**HISTORIC PRESERVATION REVIEW BOARD
STAFF REPORT AND RECOMMENDATION**

Landmark/District:	Mount Pleasant Historic District	(x) Agenda
Address:	1900 Lamont Street NW	
Meeting Date:	July 26, 2018	(x) Alteration
Case Number:	18-501	(x) Permit

The applicant, Matt Weaver, agent and construction manager for property owner DARO Realty, Inc., request the Board’s review of a permit to upgrade the electrical service to a multi-family residence, including the installation of a large cabinet on the face of the building.

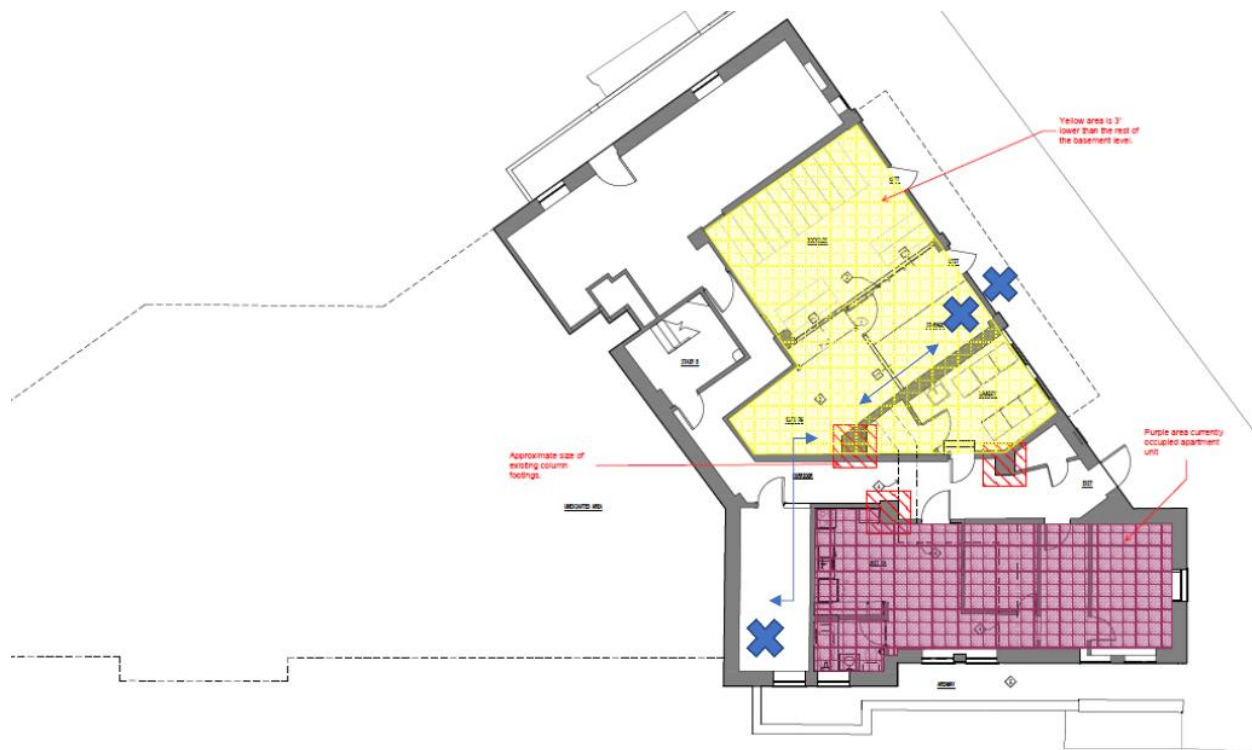
The cabinet would be located in the space between the two sets of basement windows seen here. The four conduits into the building would penetrate the masonry at about the height of the single existing one, seen at the inside corner of the building's projecting pavilion at the end of the areaway.

From the east, the upper part of the site, the cabinet would not be an issue; there are enough objects to obscure it or distract from it. It is from the public space opposite the cabinet and downhill west of it—at the lower end of Lamont—that it will be most obtrusive.

The applicant instead proposes to build up the retaining wall—which now measures about four and a half feet tall in the vicinity of the proposed equipment—to the height at its uppermost extent. The areaway floor would also be lowered so that the cabinet itself, but not its conduit, would reach no higher than the heightened areaway wall. The elevation submitted represents the proposed finished condition, roughly what one would see of the cabinet if one’s eye level were at grade on the opposite side of the areaway wall. Of course, a passerby would have a higher vantage point over the wall, and an observer on the lower end of Lamont could see the entire cabinet.

The proposal also raises other issues, in addition to the multiple penetrations of the masonry. If the wall is built up, soil should *not* be backfilled against it, because that would disrupt the terracing of the hill that occurs between the building and the public sidewalk. The taller wall also cuts off any views from the two apartment windows behind it.

HPO recommends that the Board not recommend approval of the permit application as proposed and instead encourage the applicant to place the CT cabinet inside the building as the compatible solution to the problem.

- 1. the retaining wall should be parged and the whole wall repaired;*
- 2. the cabinet product information submitted should be uploaded to the application in ProjectDox;*
- 3. the cabinet should be a matte color to roughly match that of the building’s base;*
- 4. soil should not be mounded up against the wall, but there should be plants to screen it; and*
- 5. the existing hole for the conduit shall be properly patched.*
